**APPLICATION NUMBER:** RECON 24/0610

**PROPOSAL:** CONDITIONS OF 21/0184 RESERVED MATTERS APPLICATION  
OUTLINE PERMISSION 16/0864 FOR RESIDENTIAL DEVELOPMENT  
OF UP TO 1100 DWELLINGS AND ASSOCIATED INFRASTRUCTURE

**SITE:** Llanwern Village Development Site, Phase 1 Cot Hill, Llanwern

**APPLICATION TYPE:** Conditions

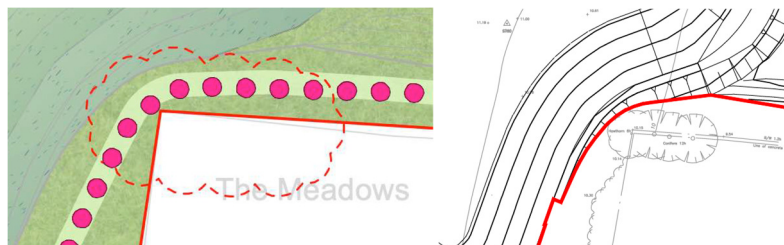
My previous comment stands ie it is feasible to provide a circular pathway but as shown below this is very tight to the south and if mowing is not sufficient, the path will become unusable.
